**BOROUGH OF HIGHLANDS**  
**LAND USE BOARD MEETING**  
22 Snug Harbor Avenue, Highlands NJ 07732  
Thursday, March 10, 2022 at 7:00 PM

**AGENDA**

REV	DATE	DESCRIPTION	BY	CHECK			
MINOR SUBDIVISION PLAN FOR <b>THOMAS FAHEY</b> LOT 6 BLOCK 14 SHEET 6 BOROUGH OF HIGHLANDS, MONMOUTH COUNTY, NEW JERSEY RICHARD E. STOCKTON & ASSOC., INC. SURVEYING & MAPPING->PLANNING->CONSTRUCTION SURVEYING PO BOX 124, ATLANTIC HIGHLANDS, NJ 07716, 732-872-2827							
RICHARD STOCKTON, LICENSED PROFESSIONAL LAND SURVEYOR & PLANNER PLS15102 PP2267							
DATE:	9-30-21	FILE:	4276	DRAWN:	RLT	JOB NO:	8158
SCALE:	1" = 20'	CAD#:	P-8158sub1.dwg	CHECKED:	Res	DWG NO:	D-1047

**Re: Farrell Residence  
 32 Shrewsbury Avenue  
 Block 43, Lot 7  
 Waterfront Transition-Residential (WT-R) Zone  
 Minor Site Plan with variances  
 First Engineering Review**

PROPOSED GARAGE RECONSTRUCTION FOR  
**FARRELL**  
 52 SHEWERSBY AVE.  
 HIGHLANDS, NJ

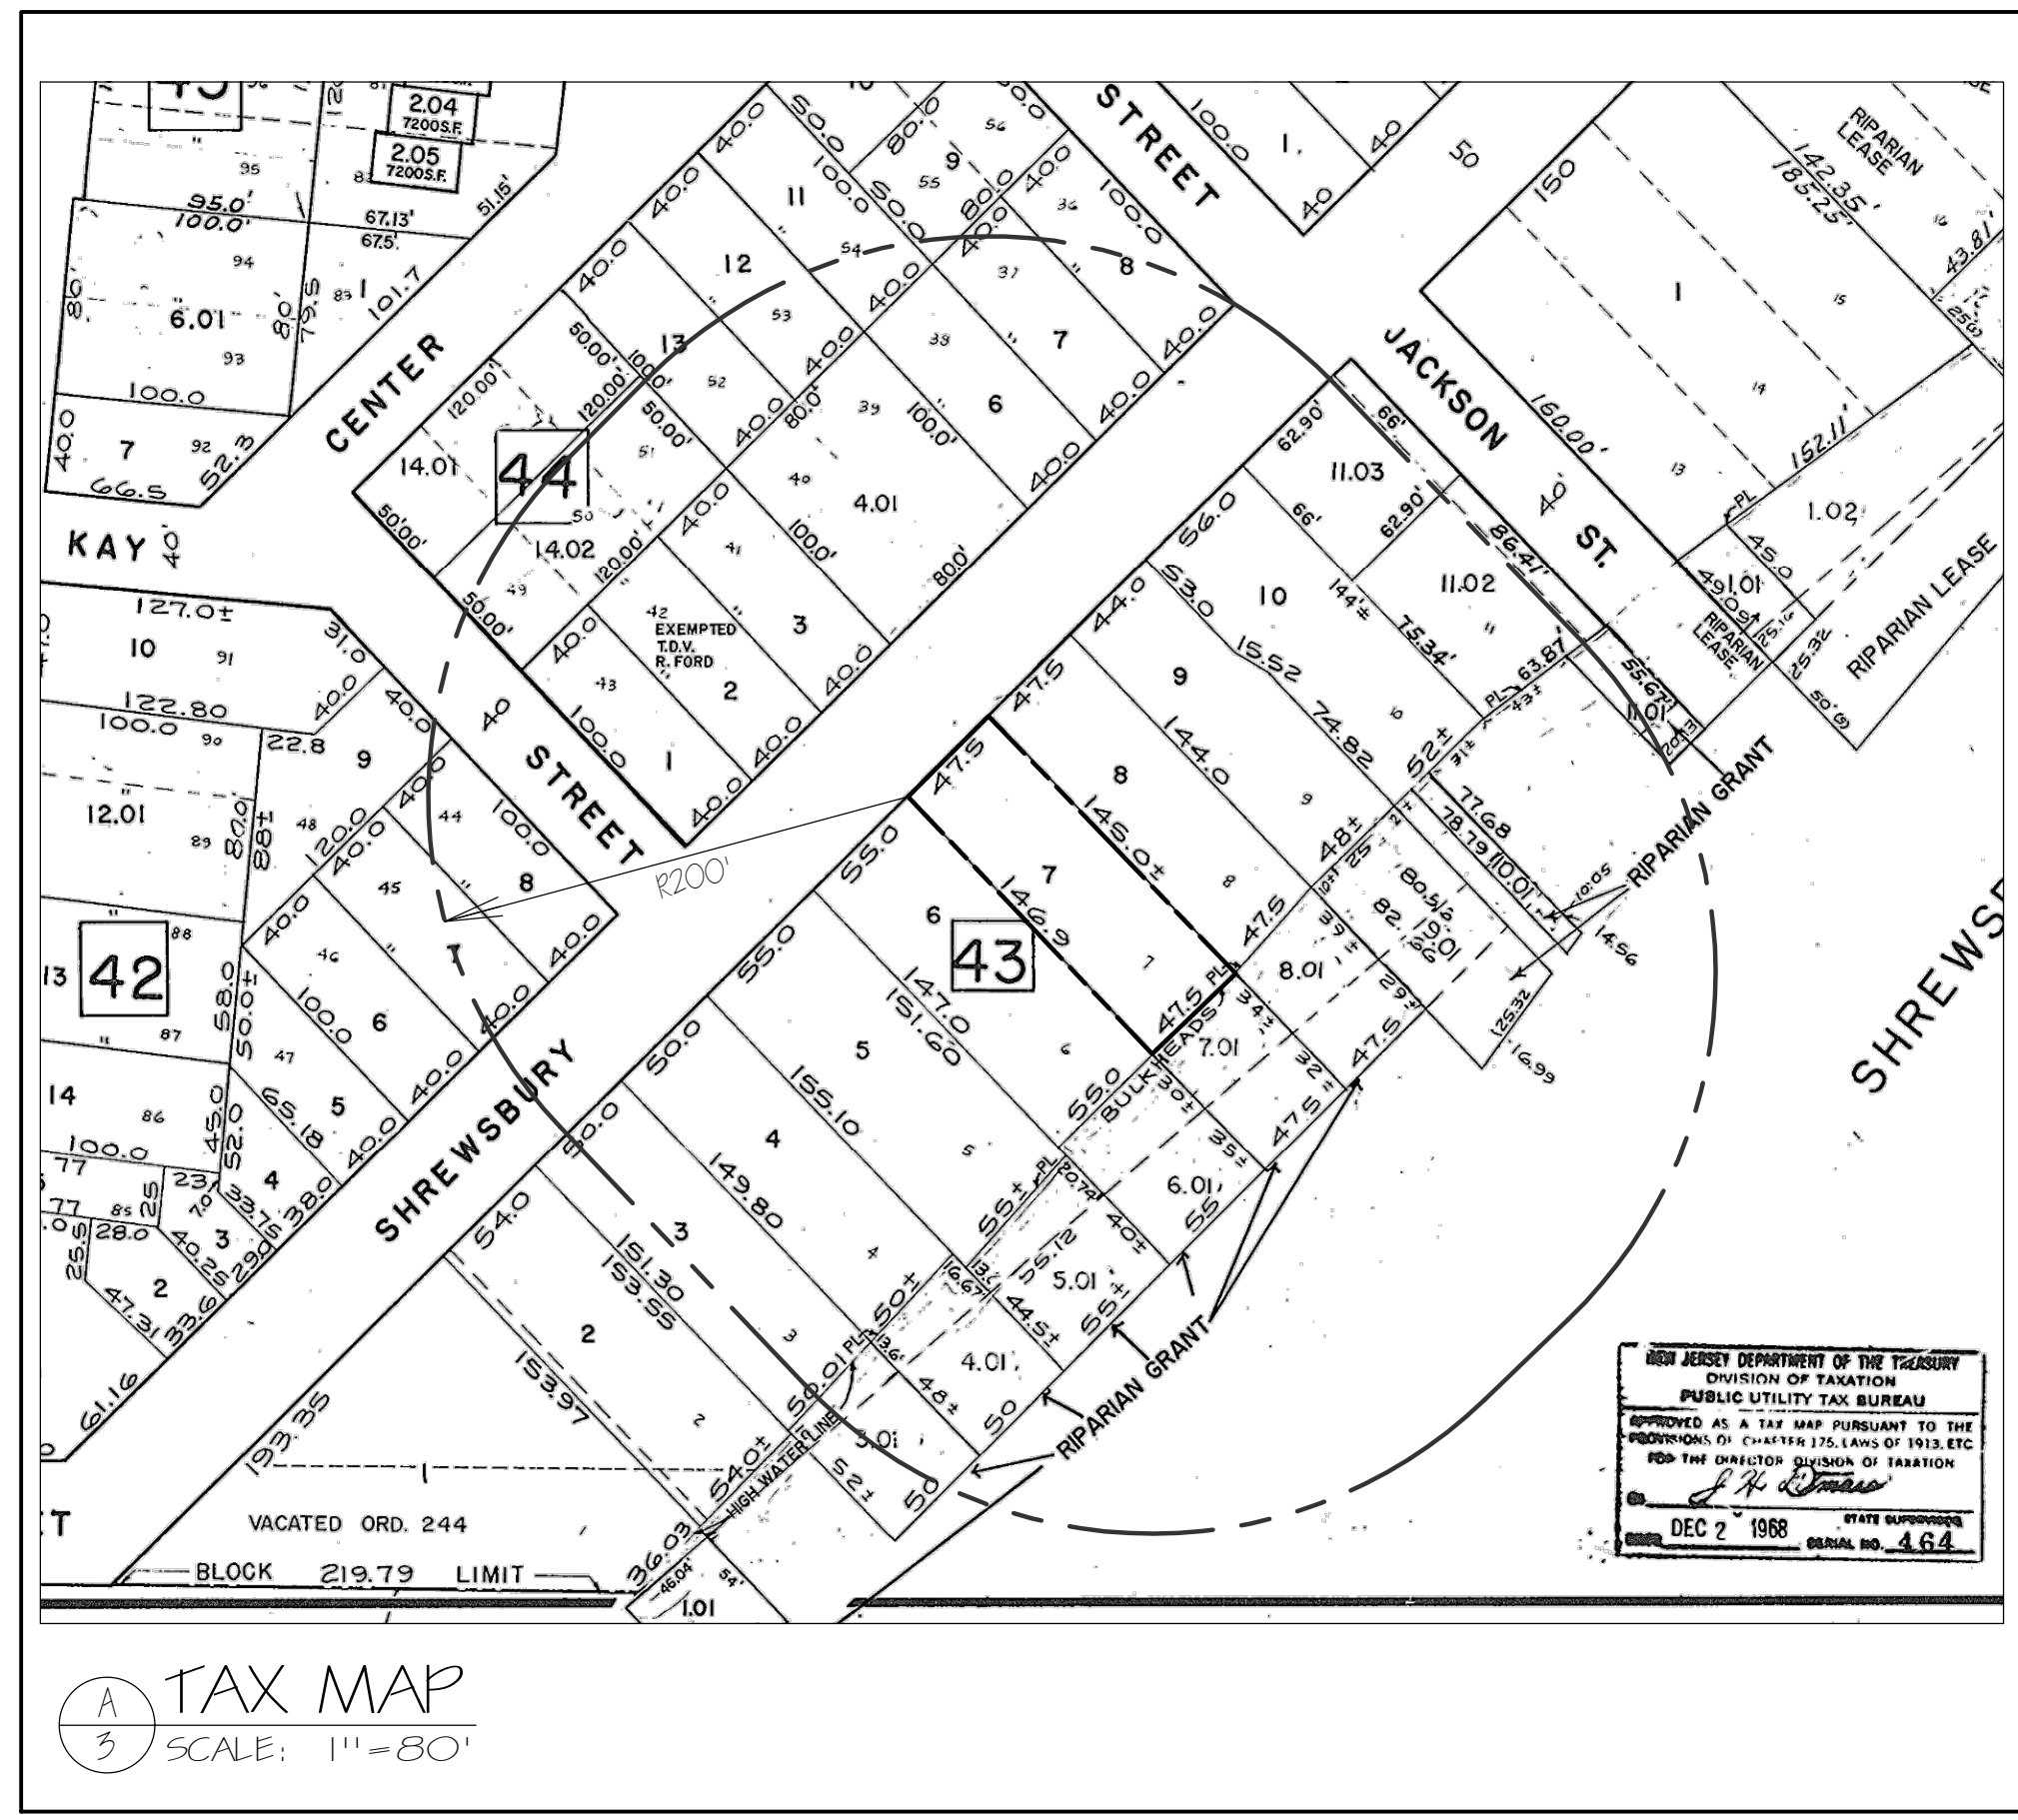
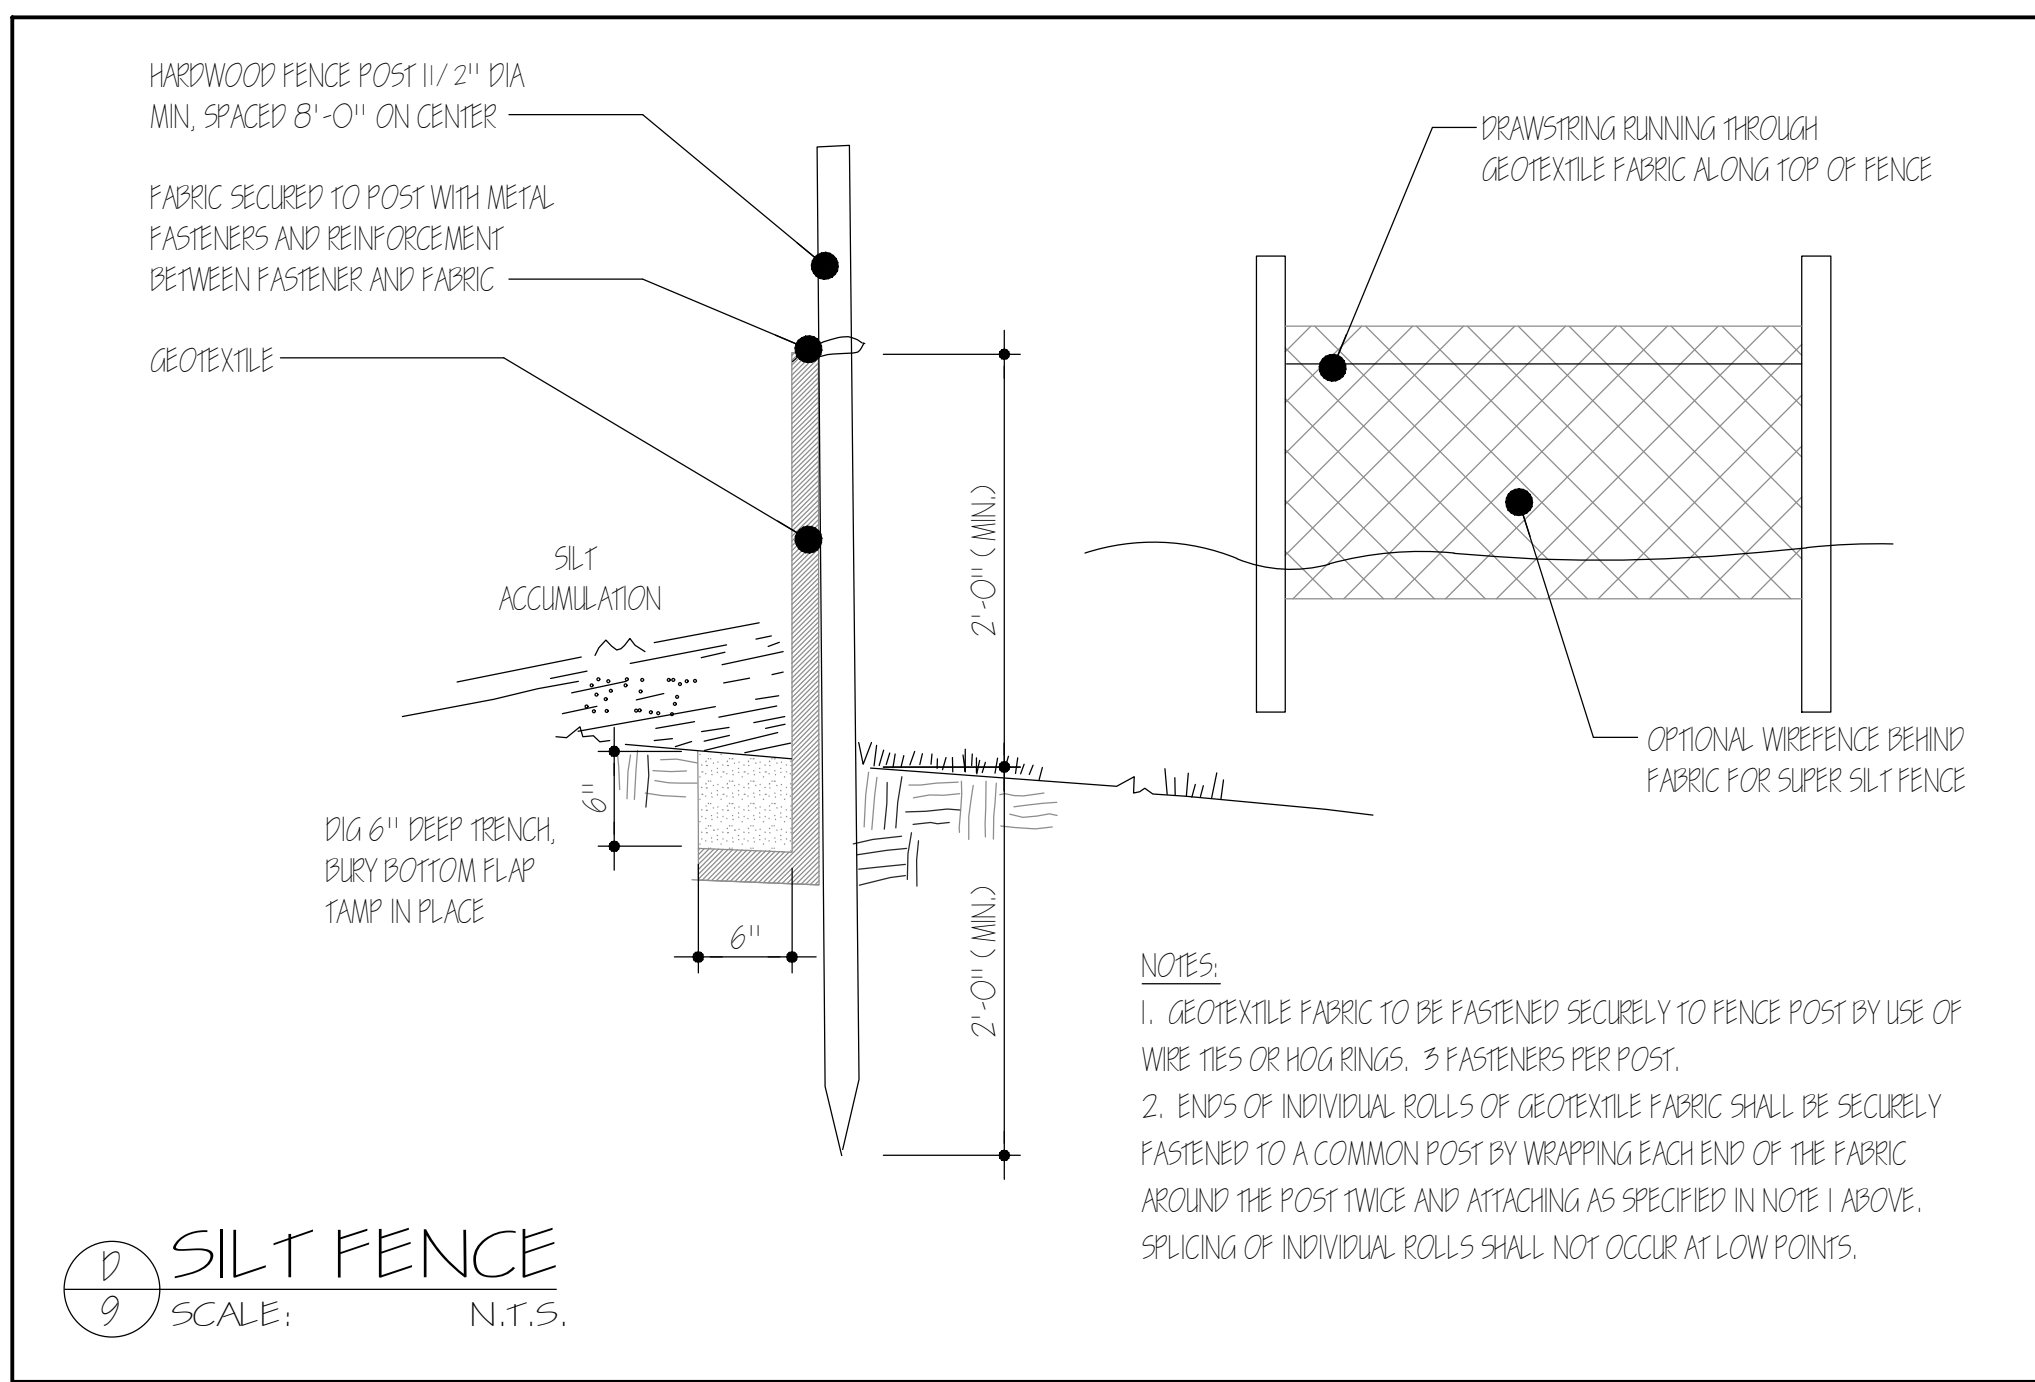
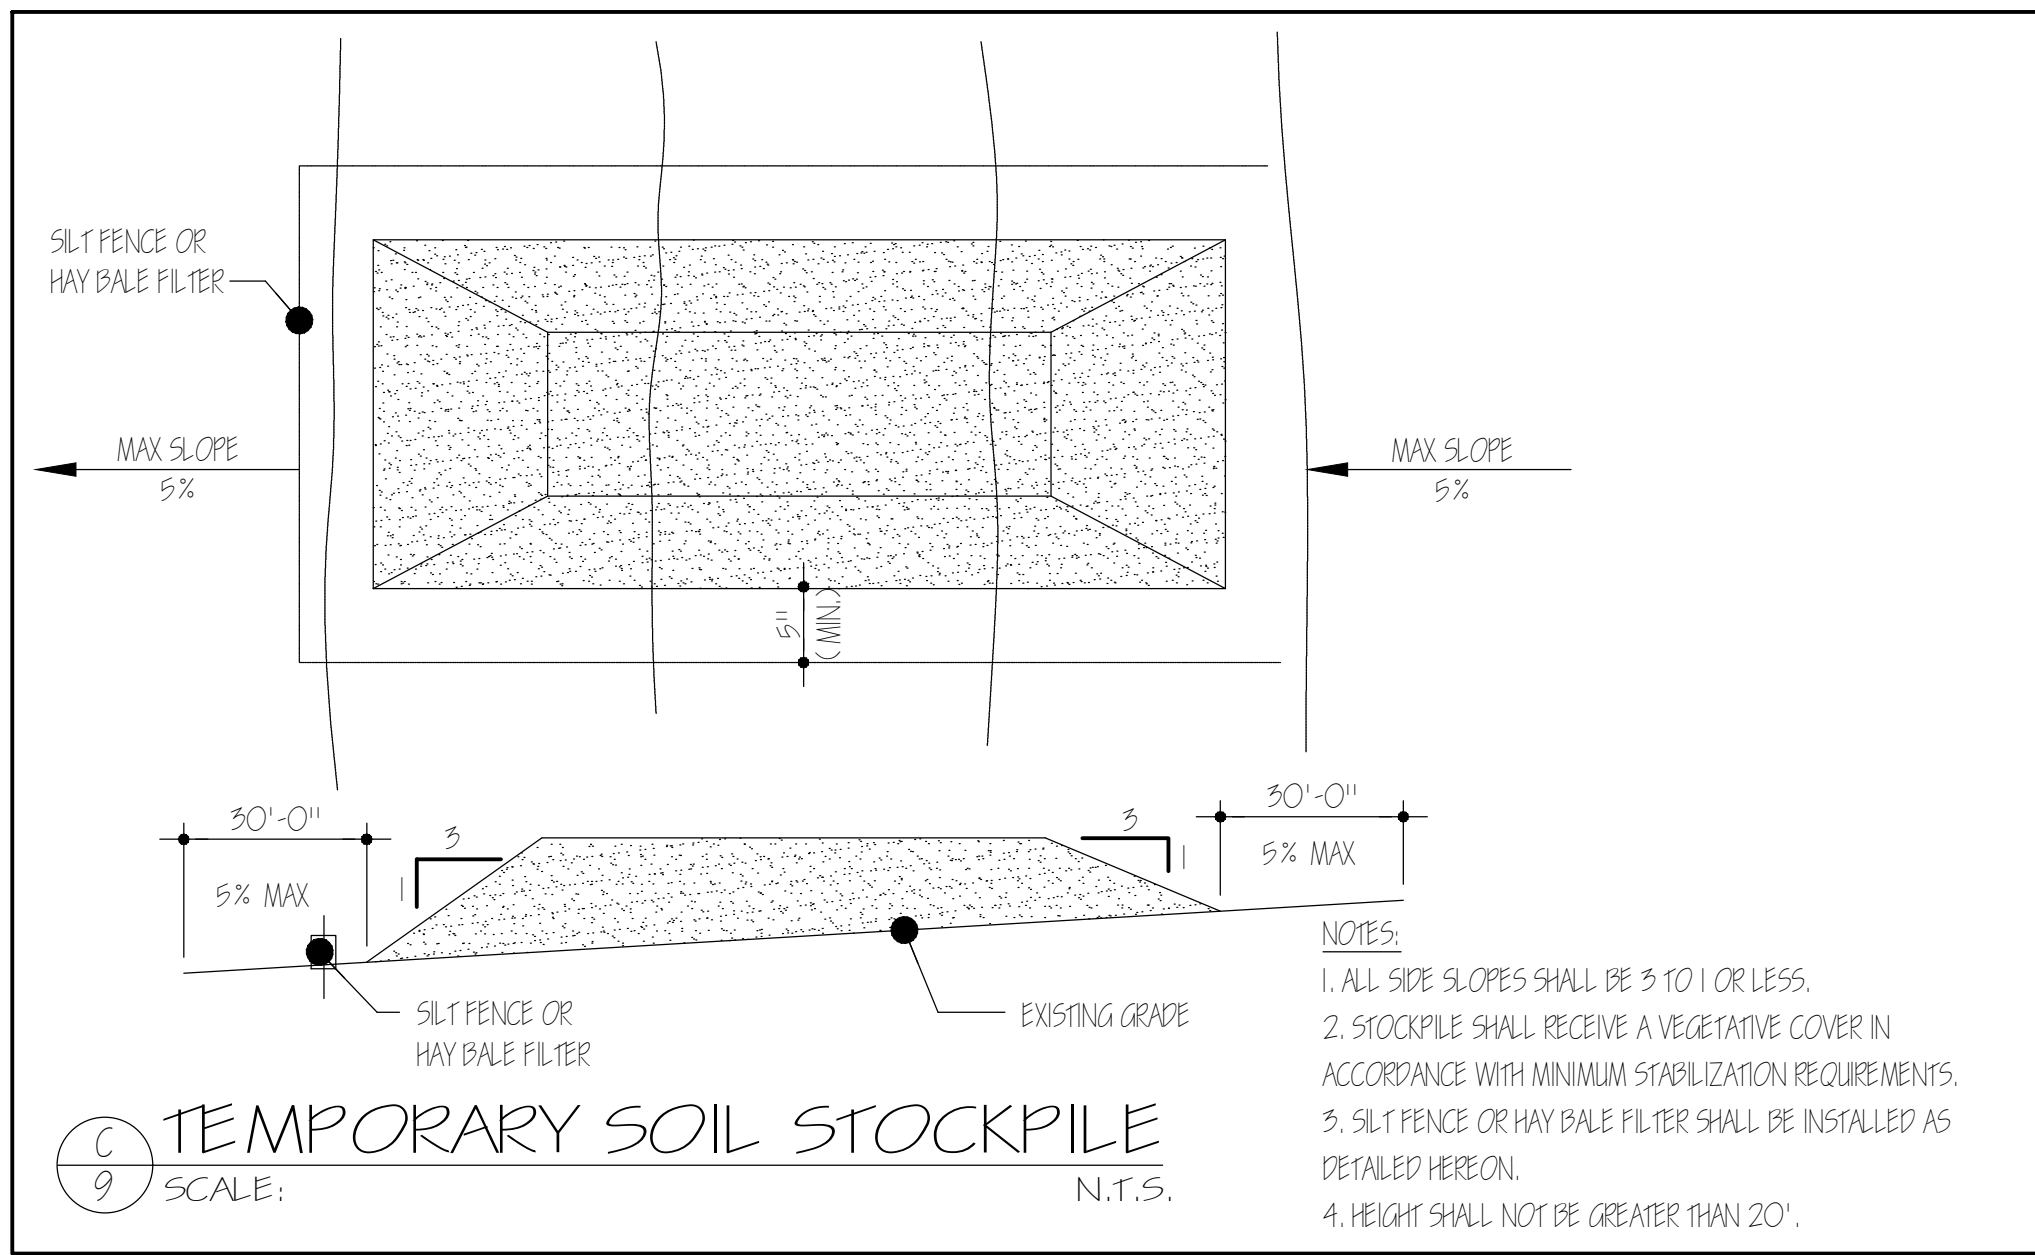
1. The applicant shall provide testimony regarding the prior existence and/or approvals for the accessory garage that is the subject of this application, as well as the circumstances surrounding its demolition. Pursuant to Ordinance Section 21-98.C:

4. The applicant shall provide testimony on how the garage was damaged and the need for its reconstruction.
5. Pursuant to Ordinance Section 21-65.10A (Landscaping and Street Trees), “All areas not devoted to structures, paving, or other required uses shall be appropriately graded, landscaped and maintained in accordance with a landscaping plan approved by the Board”. The Board should determine if a landscaping plan is required.

7. The applicant shall provide testimony on any drainage impacts to the adjacent residential properties as a result of this application.

8. A note shall be added to the plans stating that any/all existing curb, sidewalk, roadway, and other off-site objects damaged by construction should be repaired and/or replaced to the satisfaction of the Borough Engineer.
9. Approvals or waivers should be obtained from any agencies or departments having jurisdiction.

18. Preliminary architectural plans for the proposed buildings or structures indicating typical floor plans, elevations, heights and general design or architectural styling. **Provided. The proposed structure is located within the Limit of Moderate Wave Action (LimWA) in flood zone AE-13. Therefore, the plans should be designed in accordance with FEMA standards and the Borough of Highlands Flood Damage Prevention Ordinance requirements. I defer to the Borough Floodplain Manager for further review.**
